Validation Report

VALIDATION OF THE CDM-PROJECT:
HUNAN XIAOTAN HYDROPOWER PROJECT

REPORT NO. 600500034

2010, June 21

Figure 1: The proposed project activity with respect to similar projects against capacity and total investment

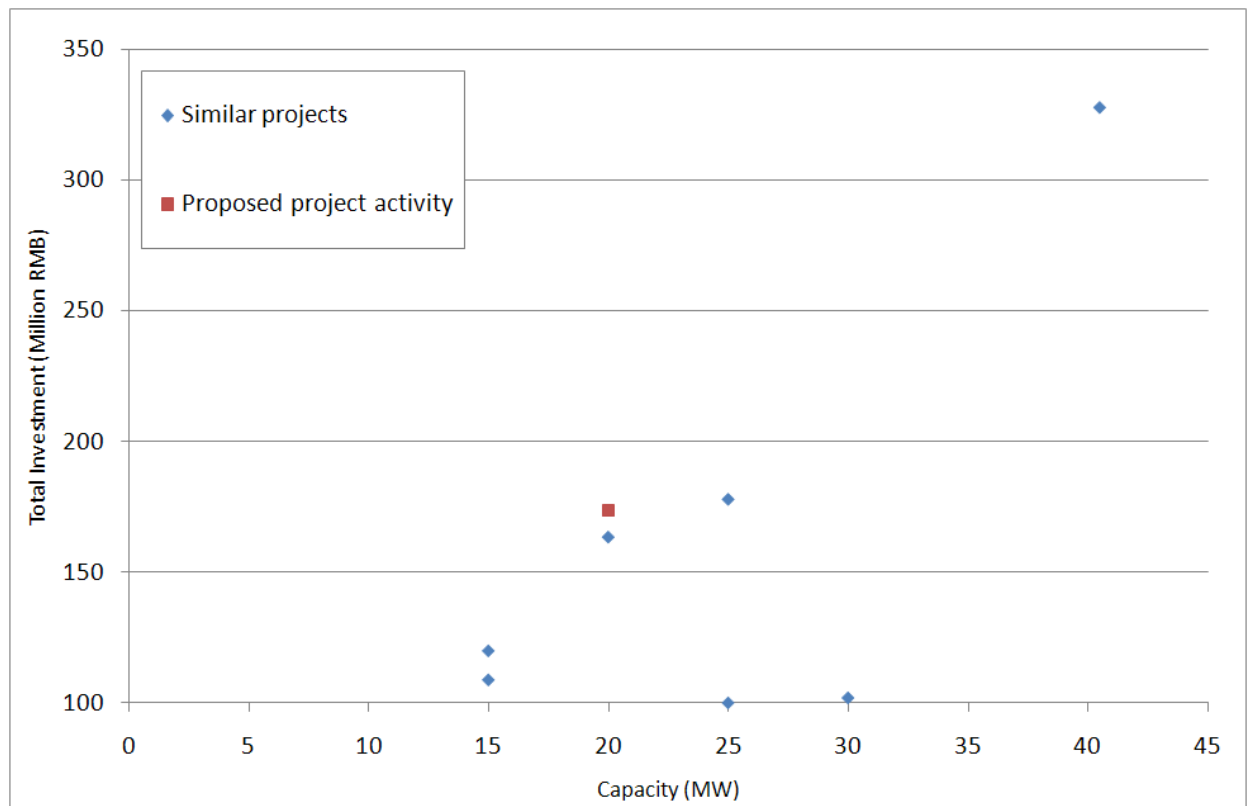
As it can be seen from figure 1 the proposed project activity is the one project which has the highest total investment compared to its capacity. All other similar projects are facing less unfavorable conditions.

Figure 2: The proposed project activity with respect to similar projects against total investment and annual power generation

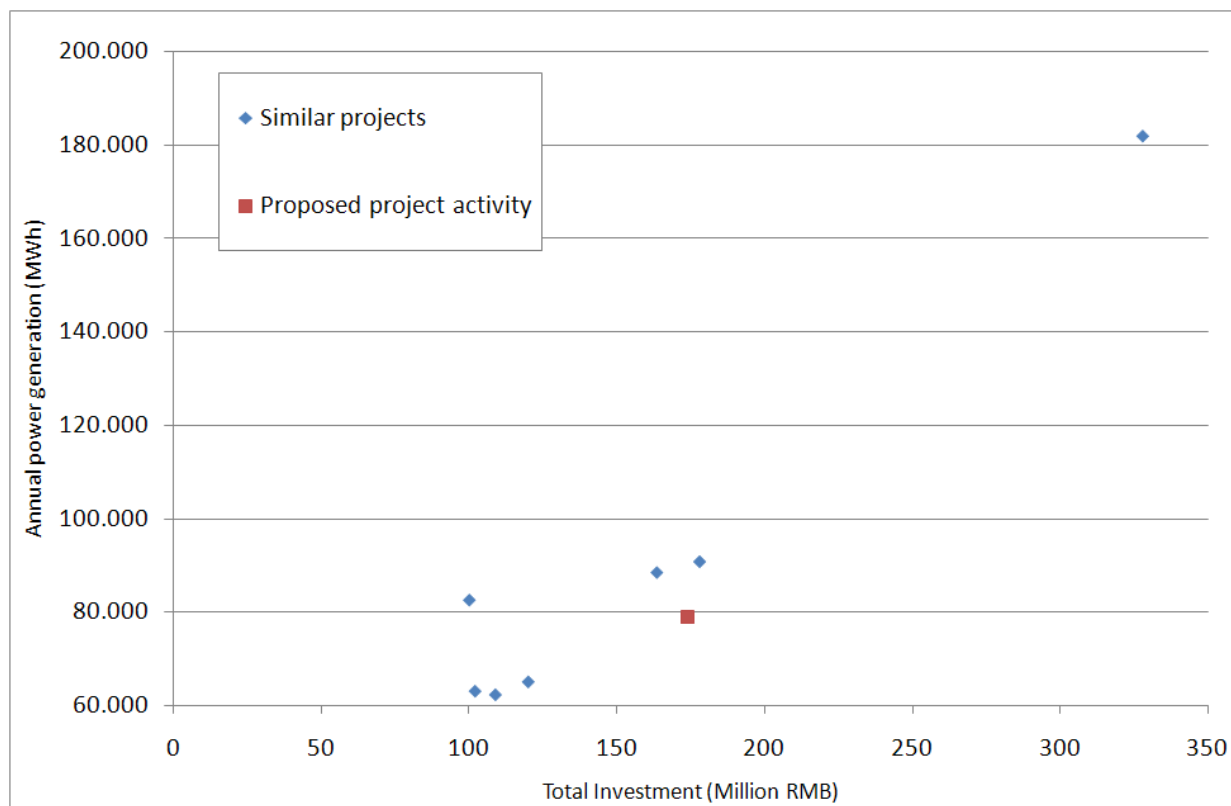
The same can be clearly seen from figure 2, where the proposed project activity has the highest investment cost in comparison to its annual power generation.
